## **MEMO**

**Project No.:** 419.01

**Subject:** Hoke Meadows Restoration-Construction Phase Services

This memorandum (memo) addresses a revision to the culverts for the Improvement Plans for Hoke Meadows Restoration Culvert Improvements project (Project). Due to constructability challenges, the Truckee River Watershed Council (TRWC) desires to eliminate two (2) of the four (4) proposed new culverts.

SECTION A-A SCALE: 1"=20' (H), 1"=5' (V)

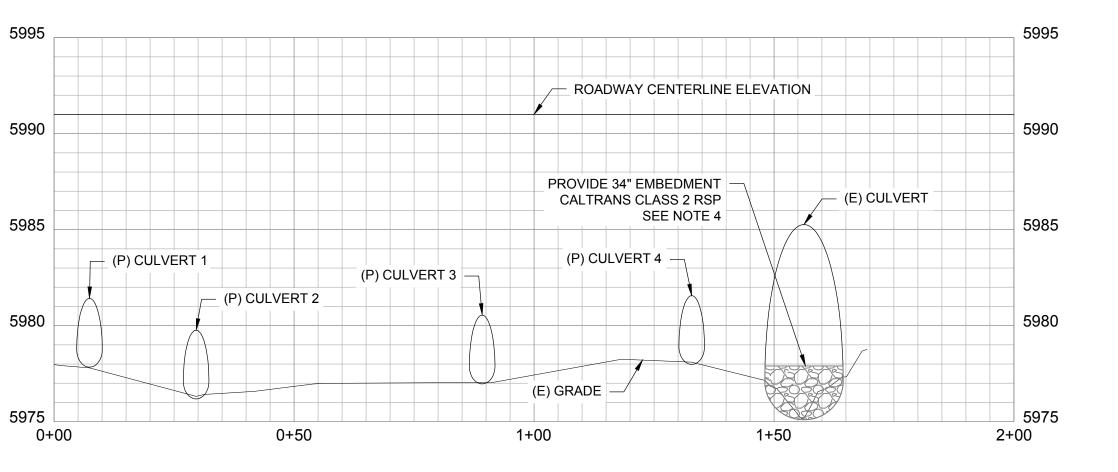
The proposed revision is shown on the attached marked up plan sheet from the 2020 project improvement plans. This revision entails the following:

- Keep the proposed 34" rock embedment in the existing culvert per the 2020 project improvement plans
- Eliminate the two culverts per the attached
- Upsize the two-remaining culverts to 83" span by 69" rise structural plate arch culverts

The attached HY-8 hydraulic analysis shows the above results in a road overtopping flow rate of 1,677 cfs, which is in excess of the existing condition flow of 1,612 cfs.

The revised culvert sizing supports the basis of design for the Project.
